ADDENDUM:

2

PROJECT NAME: Central Office 600 Building Canopy

Central Office 600 Building Canopy
Addendum #2
EXHIBIT A

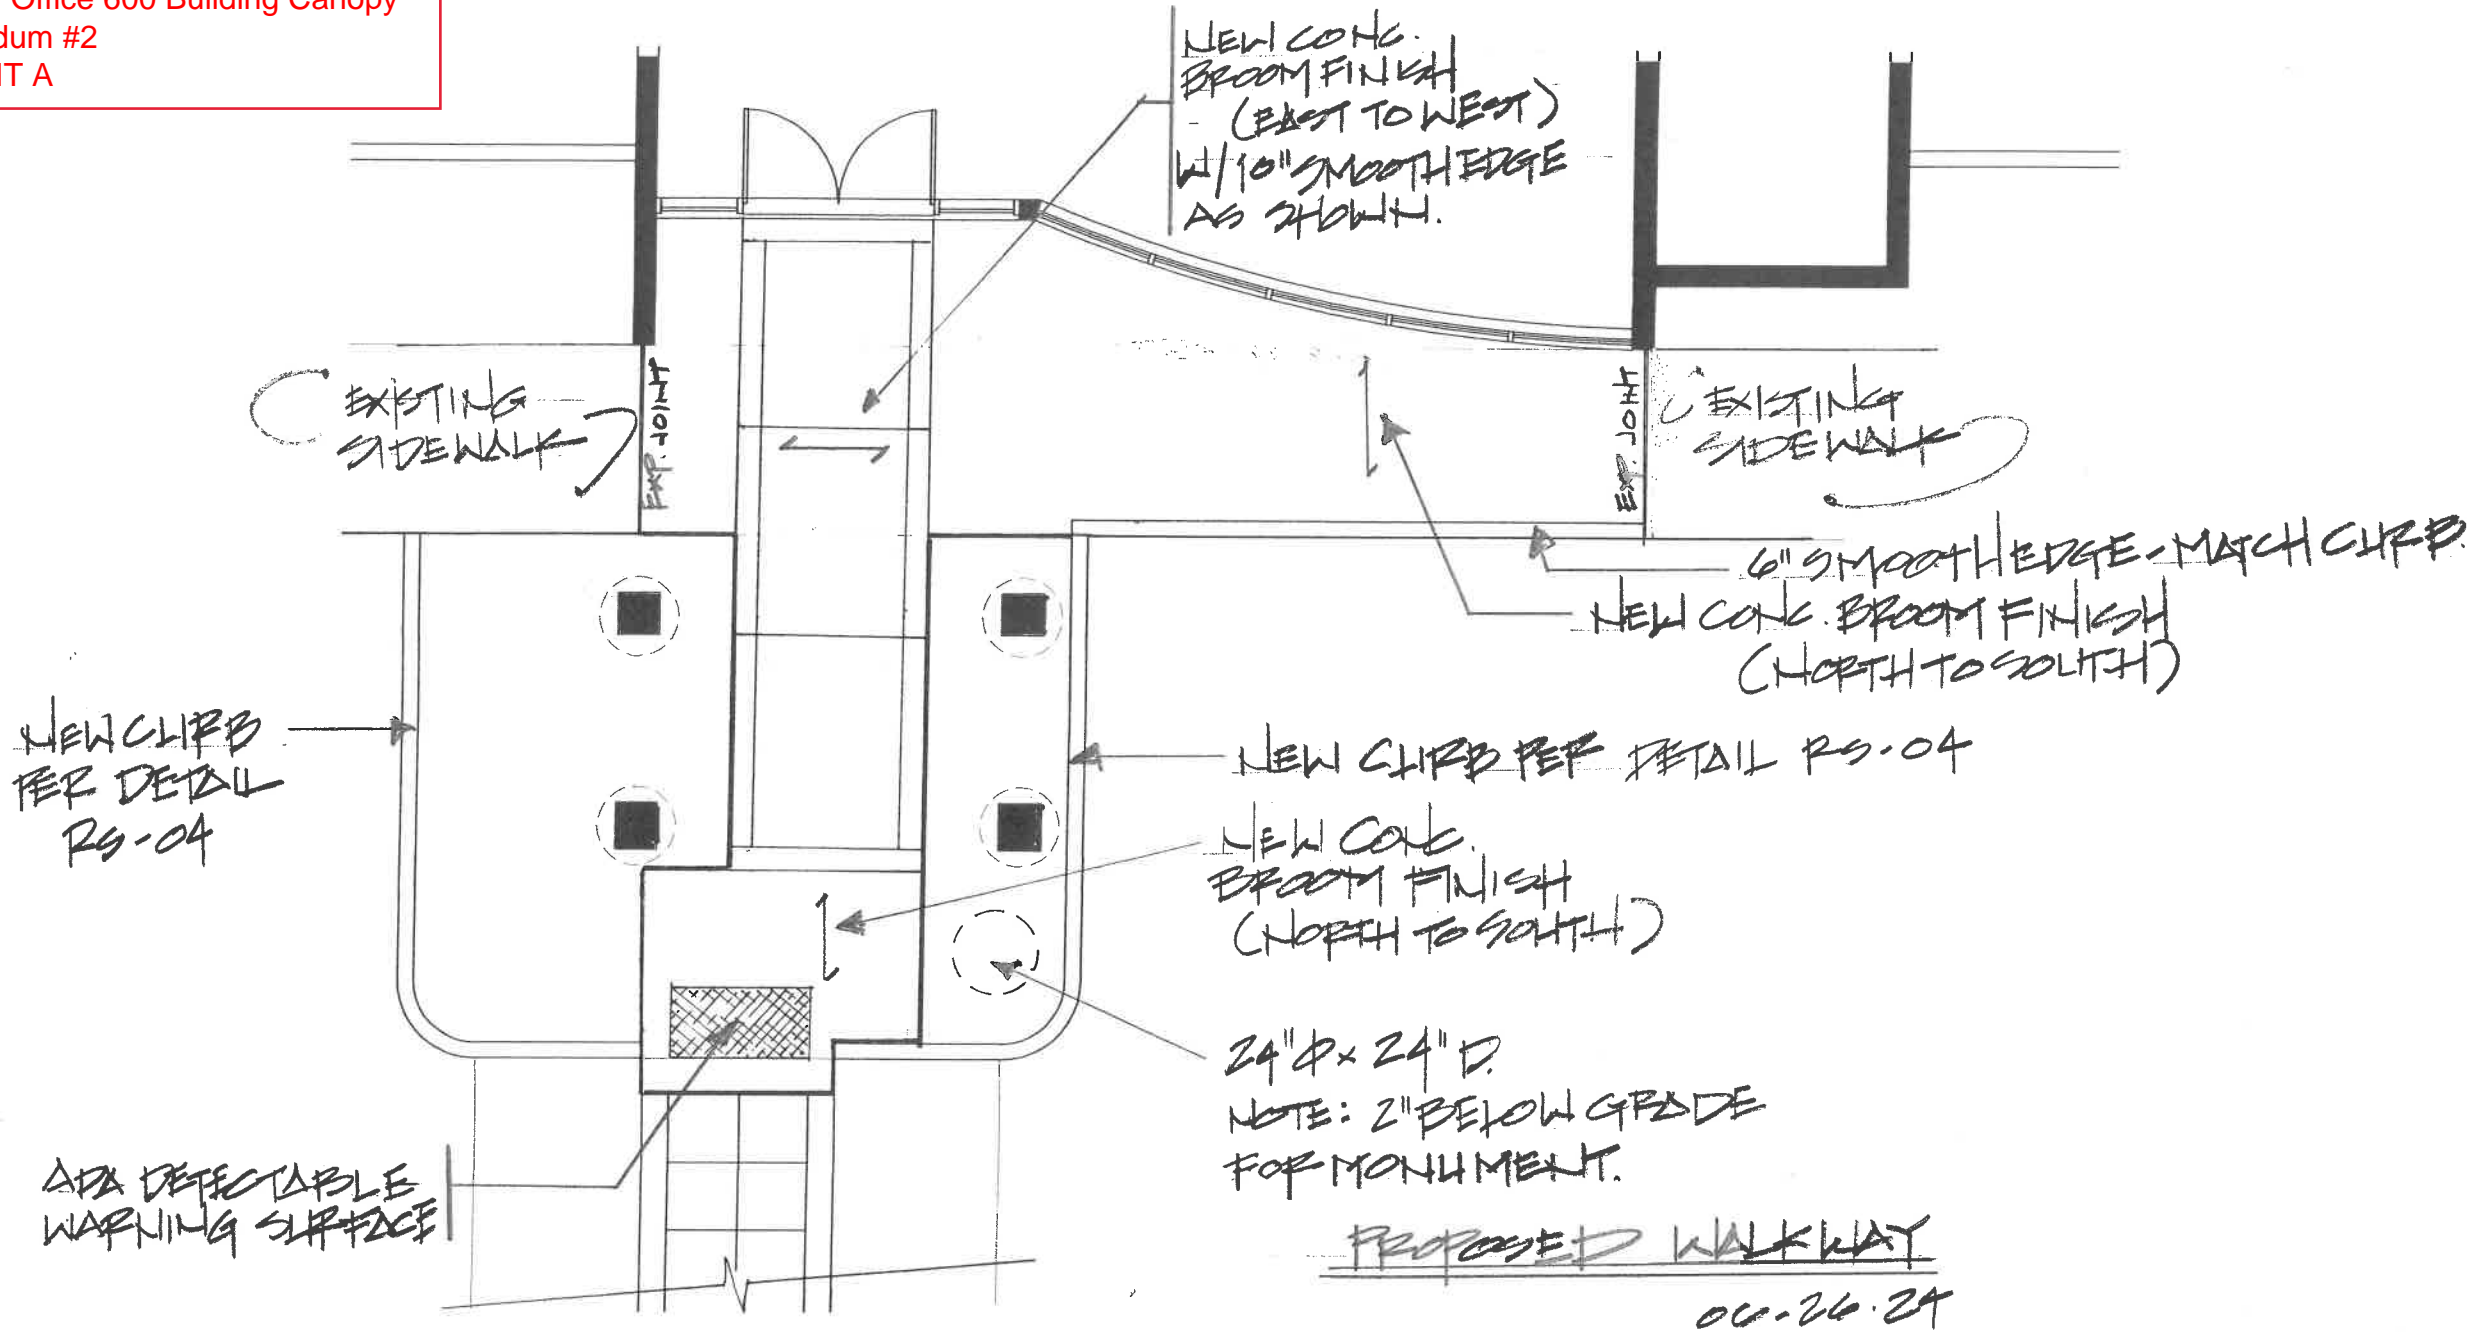
C1.0 Change "Site Plan" Concrete layout and finishes and "Detail A" to "Exhibit A" Attached

SHEET: **RS-04**

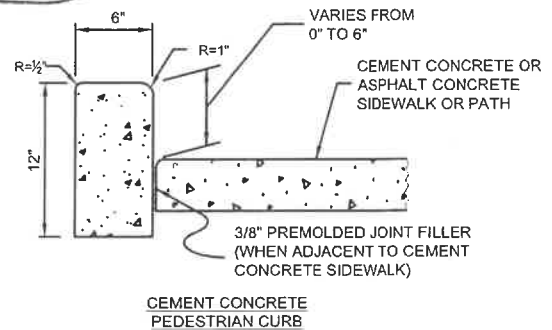
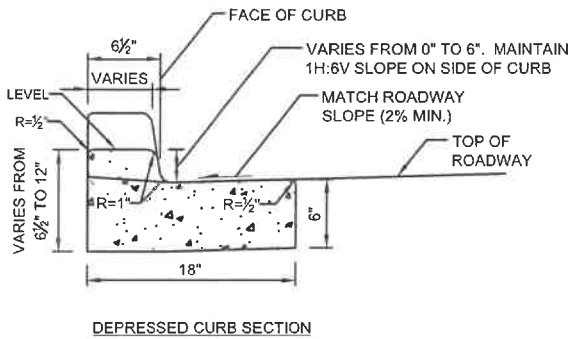
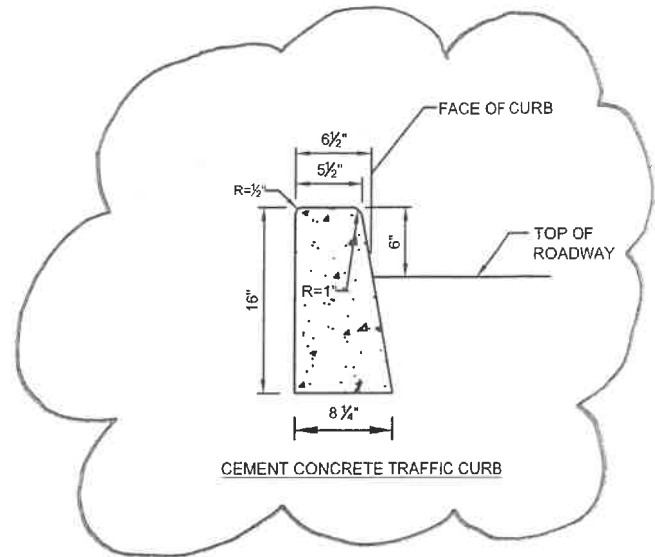
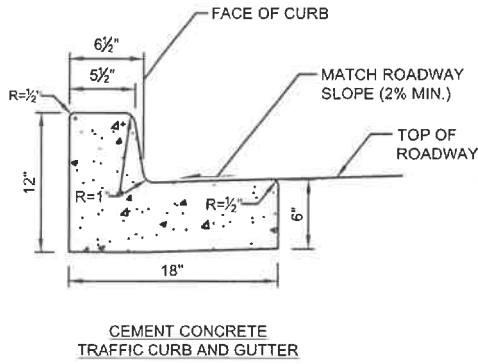
C1.0 - Site Plan notation "CONCRETE TRAFFIC CURB PER CITY OF TUKWILA STD. DETAIL RS-04" Refer to Exhibit B attached for reference.

Contractor will include the excavation of existing soils and asphalt to install proper formwork. Curbing will include (1) #5 horizontal rebar and #5 dowels at 48" o.c.
Refer to Scope of work Division 3- Concrete for bidding purposes.
